**Before the Commissioners appointed by Canterbury
Regional Council**

IN THE MATTER OF Applications by the Central Plains
Water Trust and Central Plains
Water Ltd. to Take and Use Water
for Irrigation in the Central Plains
area.

Section 42A Officer's Report

Further supplementary report of DAVID MICHAEL SCOTT

Figure 1: Groundwater gradient measured adjacent to Crossbank (south bank of the Waimakariri River in the vicinity of Christchurch airport) together with mean daily flow recorded at the State Highway 1 recorder site.

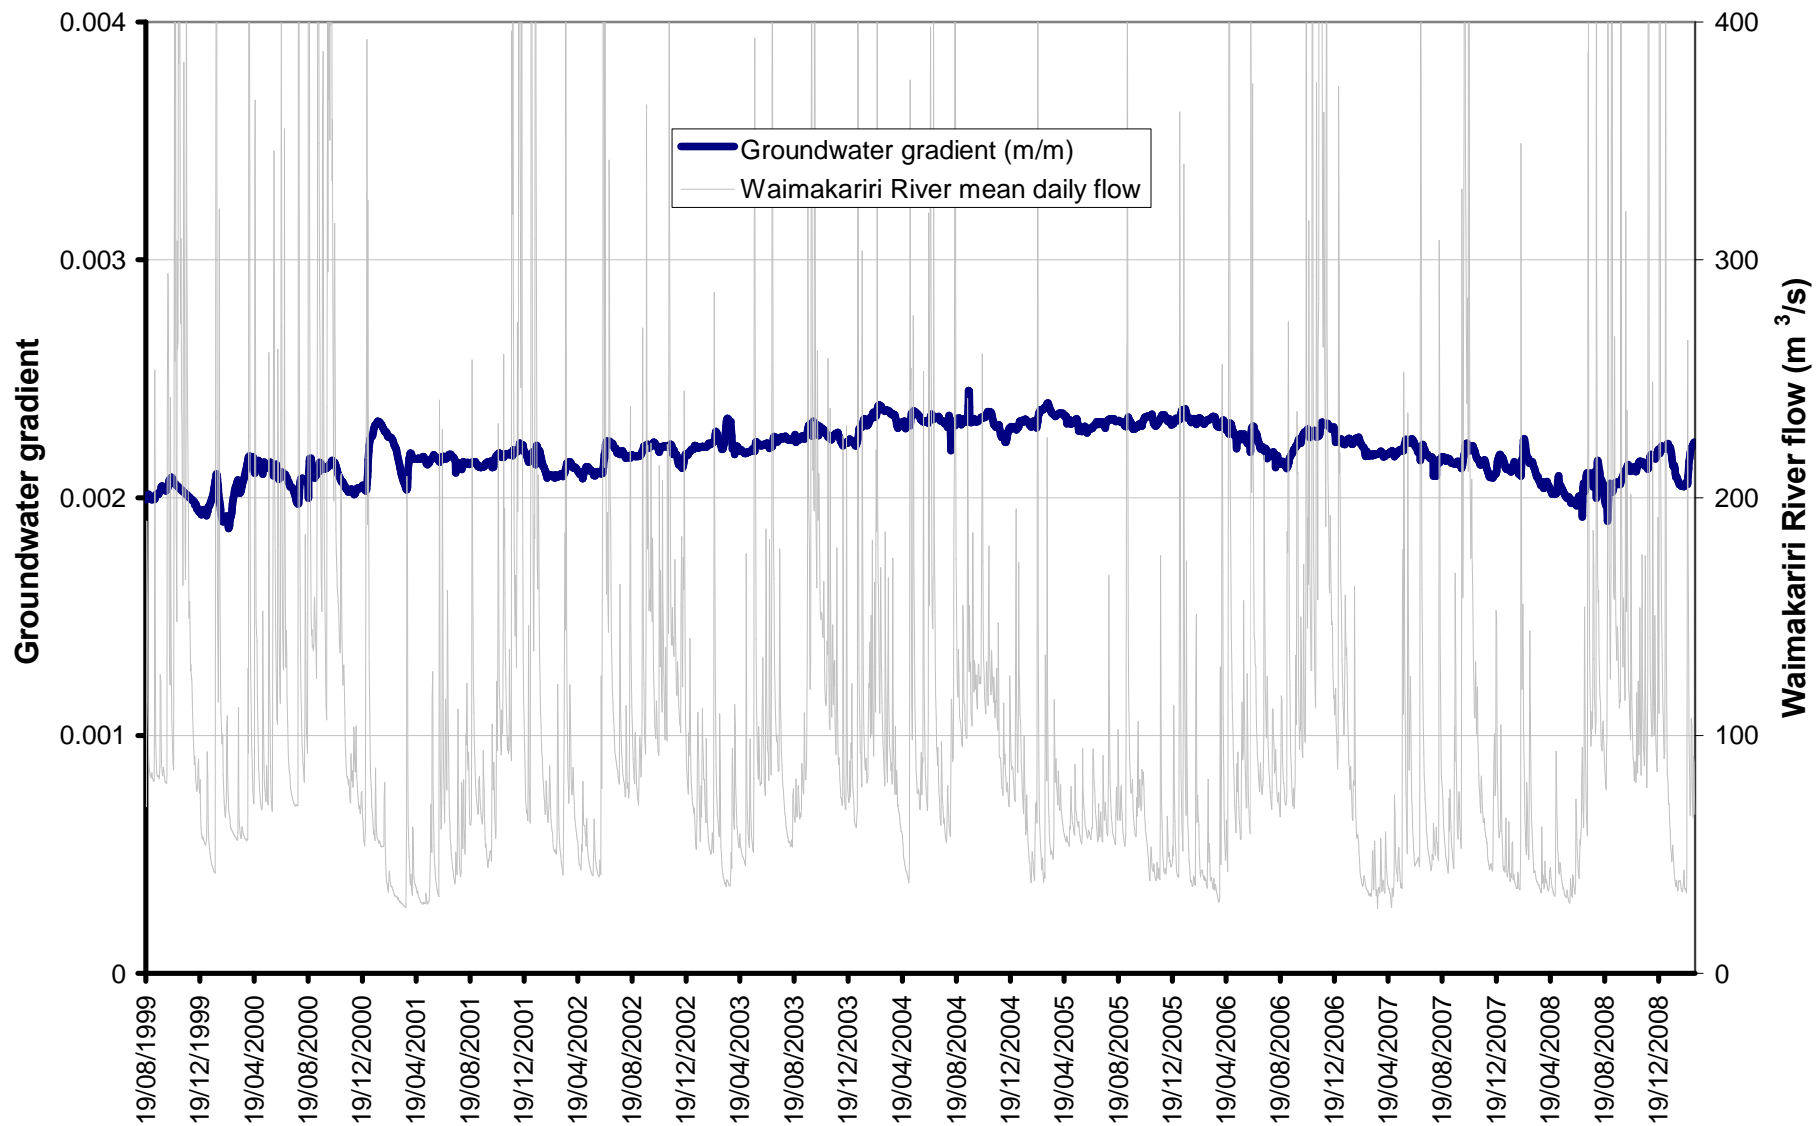
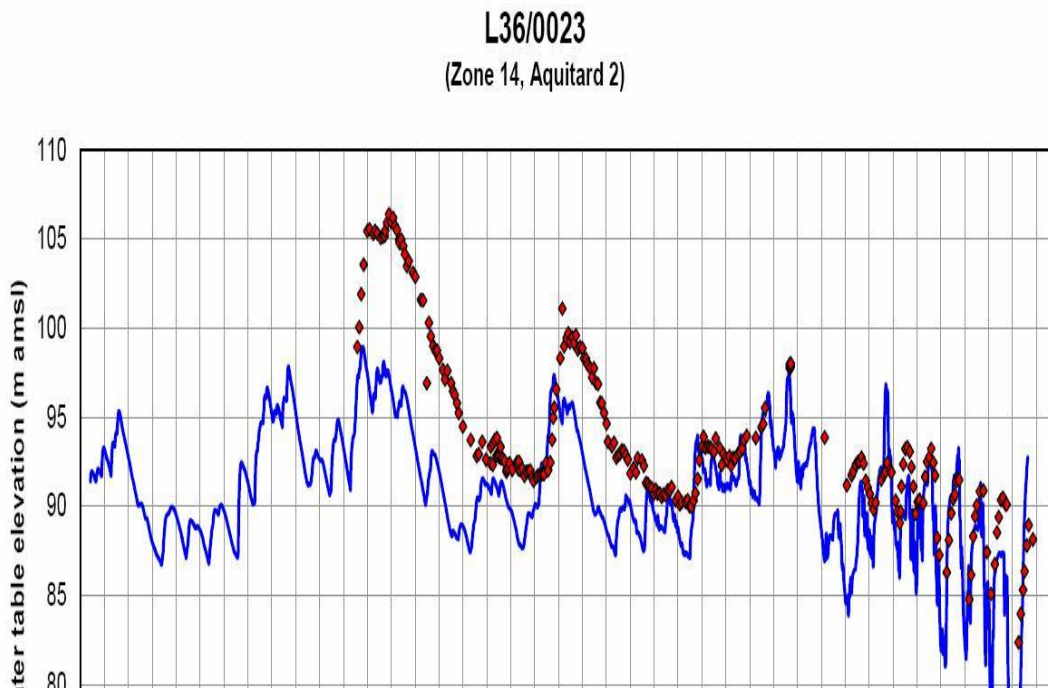
- *The assumption of constant recharge from alpine rivers*
The relative success of the Eigenmodel in being able to explain observed groundwater level variation in terms of land-surface recharge demonstrates that the assumption of constant recharge from alpine rivers is a reasonable one. Field observations provide supporting evidence that river recharge rates may be relatively steady. Environment Canterbury's monitoring of groundwater levels in an array of bores on the south side of the Waimakariri River has demonstrated that groundwater gradient away from the river has been remarkably steady over the last ten years (mean gradient 0.0022 m/m, standard deviation 0.0001 m/m) as shown in Figure 1. The simulated river recharge reported in Appendix N of Mr Weir's original evidence shows larger fluctuations and it is possible that the numerical model may be exaggerating this effect.

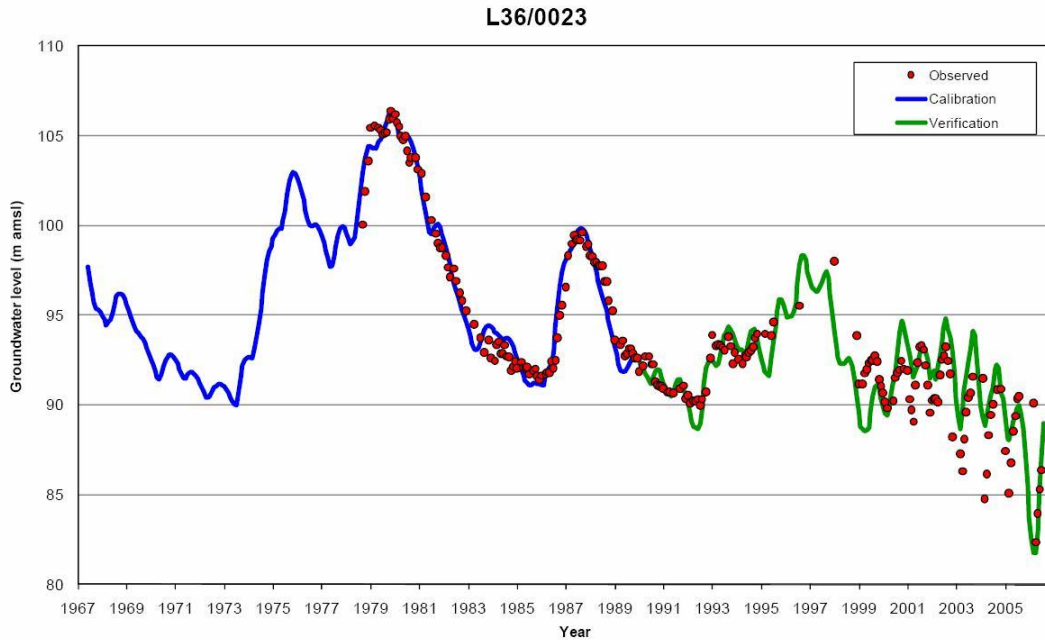
8. I have reproduced (in my Appendix A) the relevant plots from Mr Weir's Appendices F & G to show the Eigenmodel and numerical model results for each well on the same page and to an approximately equal vertical scale. For two of the wells (L36/0023 and L36/0092) the Eigenmodel provides a markedly better fit over the 1970s than the numerical model. The results for both models are roughly comparable for well L36/0142, though the numerical model

L36/0142

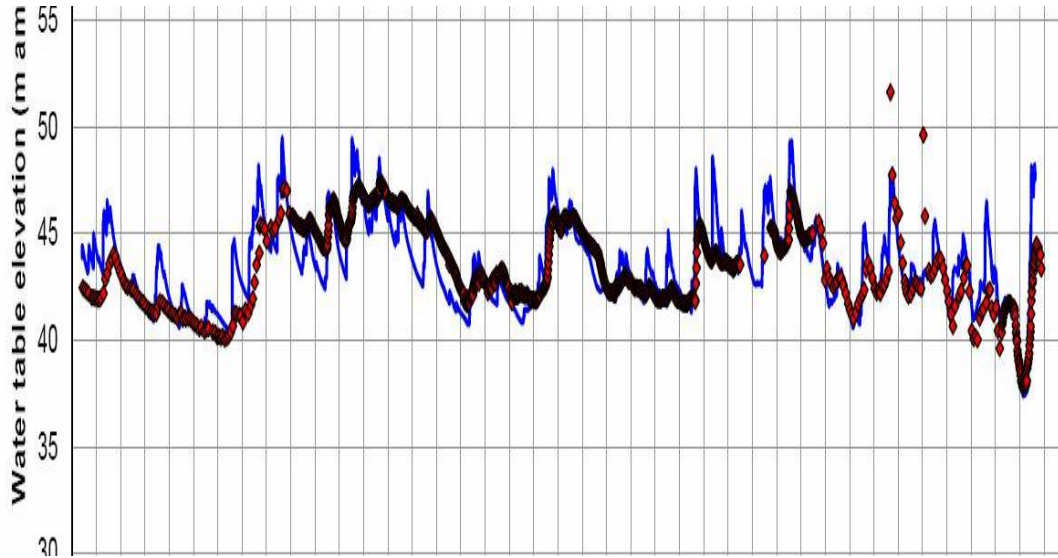
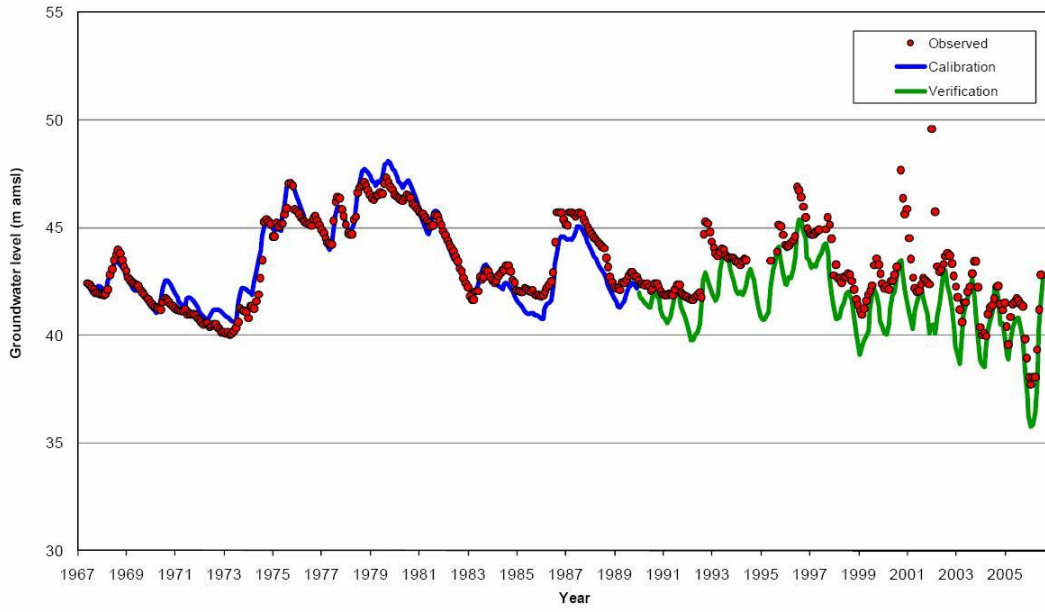
does exaggerate the annual cycle. For well M35/1080 the numerical model somewhat overestimates the water level range over the 1970s but provides a fit that appears to be superior to the Eigenmodel. It is difficult to make a clear comparison for the remaining well (M37/0010) - the Eigenmodel provides a satisfactory fit but it is difficult to assess the numerical model performance because of the vertical scale used in the original plot. On the basis of this simple evaluation I believe that it is reasonable to regard the Eigenmodel mounding estimates as being more reliable in the inland section of the study area. For the rest of the area it is not clear which method is likely to be more reliable.
